Post Exhibition - Planning Proposal - 85-93 Commonwealth Street, Surry Hills - Sydney Local Environmental Plan 2012 Amendment

File No: X096329.003

Figure 4. An excerpt of the proposed Alternative Height of Building Map

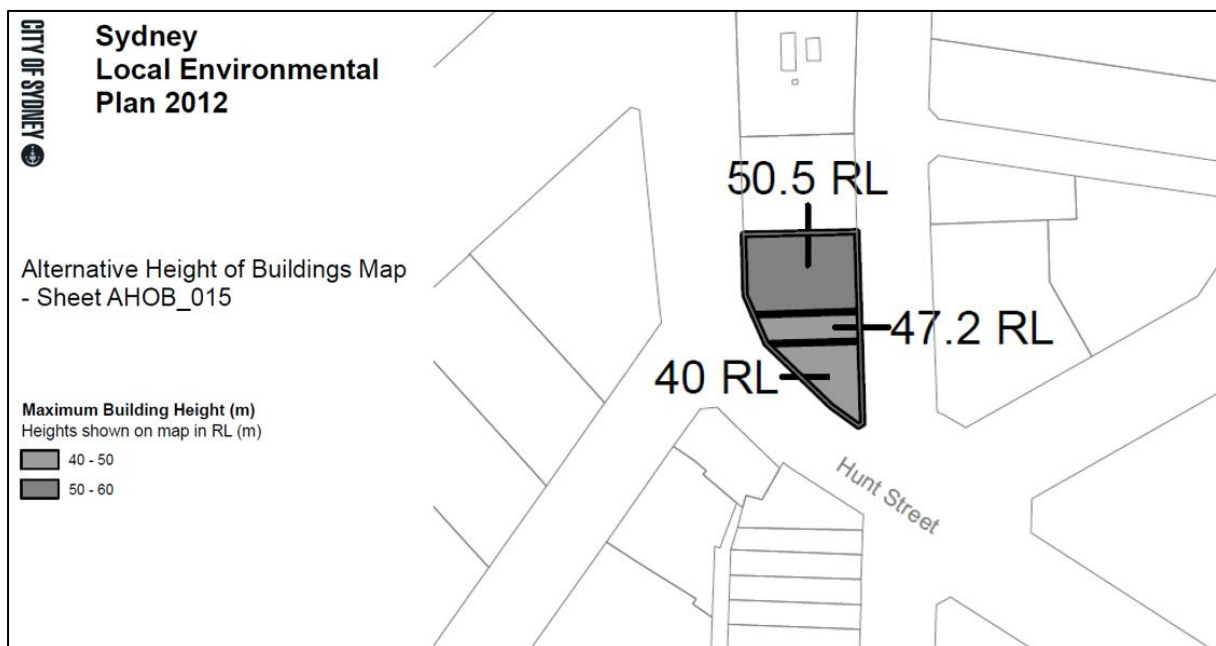
21. Six submissions raised concerns about the proposed envelope overshadowing the private open space of a terrace dwelling south of the site. Specific points raised related to the adverse impacts on liveability and property values. The exhibited envelope would cause additional overshadowing (compared with a maximised LEP-compliant envelope) to the private open space of the terrace dwelling between 10.30am and 11.30am on June 21.
22. Eleven submissions raised concerns about the overshadowing impacts the exhibited envelope would have on Harmony Park. These concerns focused on the potential reduction in the park's enjoyment and amenity.

10. The proposed envelope has been amended post-exhibition to reduce the heights and include an additional step in the heights. This will ensure the envelope does not overshadow the private open space of a terrace dwelling to the south, more than what is currently allowed by the Local Environmental Plan.

24. The heights have been reduced across the middle (RL 51.5 to RL 47.2) and northern (RL 51.5 to RL 50.5) parts of the envelope. This creates a southern setback that prevents the envelope from overshadowing private open space more than what is currently allowed by the Local Environmental Plan.
